APICAL INDUSTRIES, INC.		ENGINEERING CHANGE NOTICE NO. 04741				SHEET 1 OF 1	
		DWG NO. 647.7700	REV: NC	PREPARED BY J. SOTO	DATE: 11/13/2014	EFFECT ON DWG ☒ INC. ☐ UNINC.	
		DWG TITLE: STRUT ASSY					
		APPROVED BY: ENGR <i>[Signature]</i>	MFG <i>[Signature]</i>	QC <i>[Signature]</i>	EFF. NEXT ORDER		
TRANSACTION CODES (TC): A-ADD C-CREATE R-REVISE D-DELETE		REASON: CREATED NEW CONFIGURATION. ADDED F/N 5.					
5	A	647.7714	1	STRUT TUBE		△	
4	R	647.7713	1	STRUT THREAD		△	△
3	R	647.7712	1	STRUT TUBE		△	
	C	647.7703	X	STRUT ASSY			
F/N	NTC	PART NUMBER	.7703				
		QTY		DESCRIPTION		MATERIAL	SPECIFICATION
DOCUMENTS EFFECTED:				CHANGE CATEGORY			
☐ MDL ☐ INSTALL INSTRUCTIONS ☐ ICA ☐ FMS ☒ BOM				☐ MAJOR ☒ MINOR			
				DER REVIEW REQUIRED			
				☐ YES ☒ NO

ENGINEERING CHANGE NOTICE NO.

05110

DWG TITLE: STRUT ASSY

SHEET 1 OF 2
SCALE NONE
REV. A
DWG. NO. 647.7700

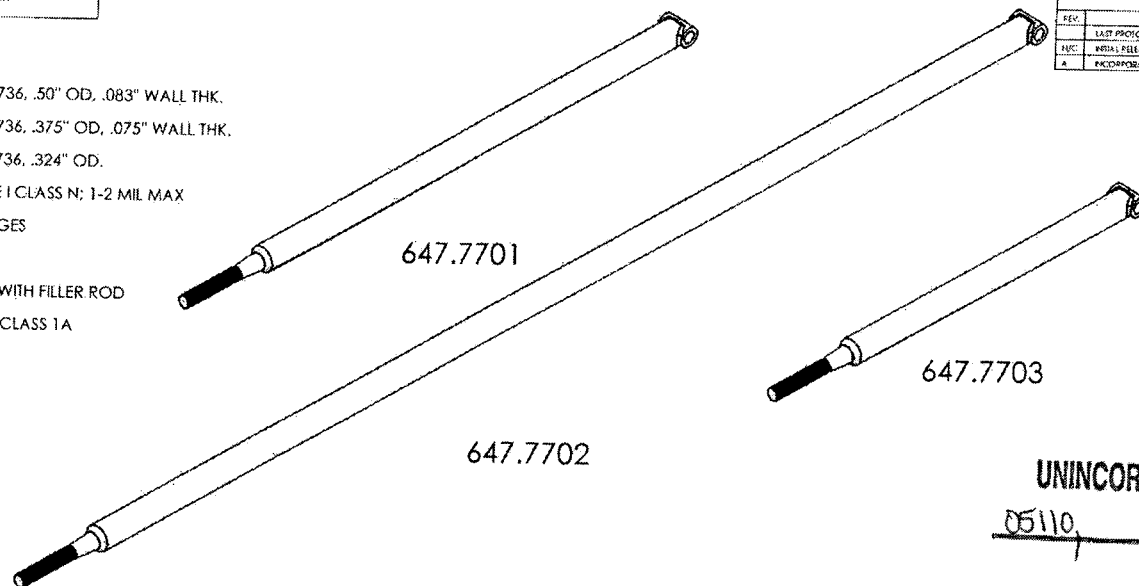
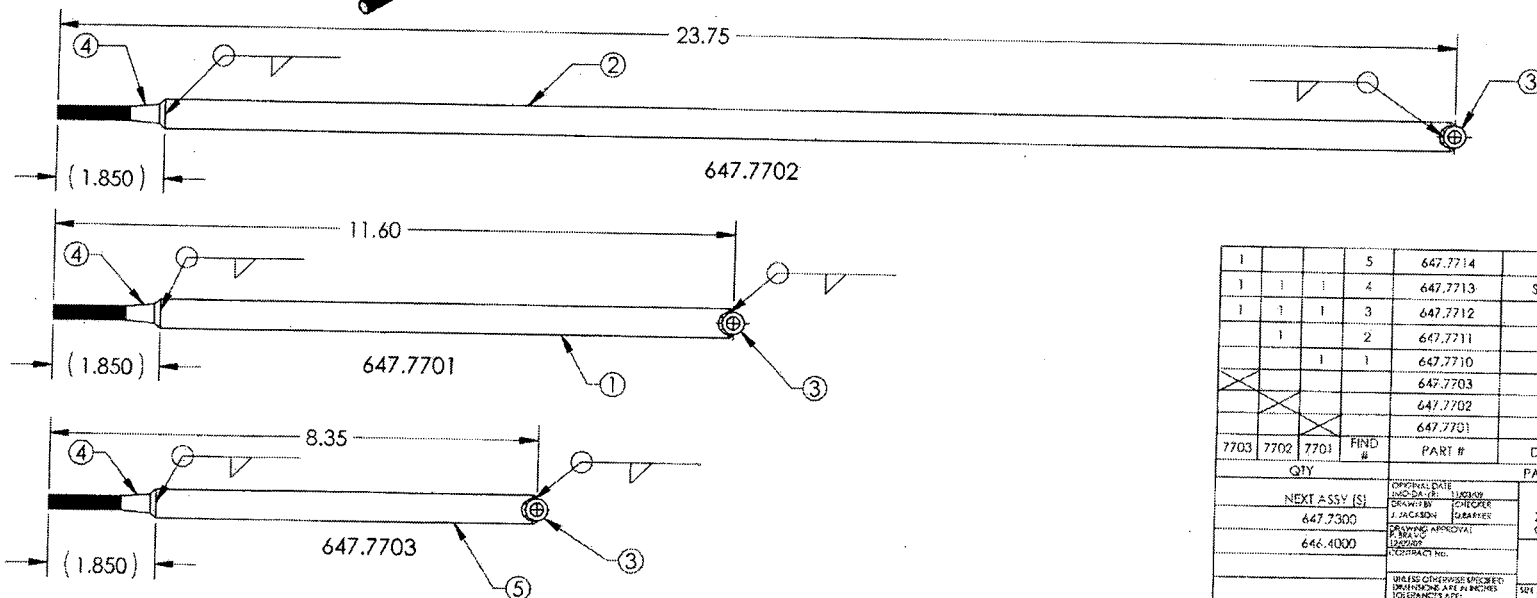
REASON: REVISED FINISH CALLOUT AS PER ECR 15-209

SHEET 1, NOTES IS:

- 1 MATERIAL: 4130 STEEL PER AMS-T-6736, .50" OD, .083" WALL THK.
- 2 MATERIAL: 4130 STEEL PER AMS-T-6736, .375" OD, .075" WALL THK.
- 3 MATERIAL: 4130 STEEL PER AMS-T-6736, .324" OD.
- 4 FINISH: PRIME IAW MIL-P-2337J TYPE I CLASS N; 1-2 MIL MAX
5. DEBURR AND BREAK ALL SHARP EDGES
6. IDENTIFY IAW MPP-120.
- 7 WELD IAW MIL-STD-2219. TIG WELD WITH FILLER ROD
- 8 FINISH: CAD PLATE IAW QQ-P-416F CLASS I TYPE II
- 9 MASK THREAD PRIOR TO FINISH

ACTION: UPDATE MO & WO
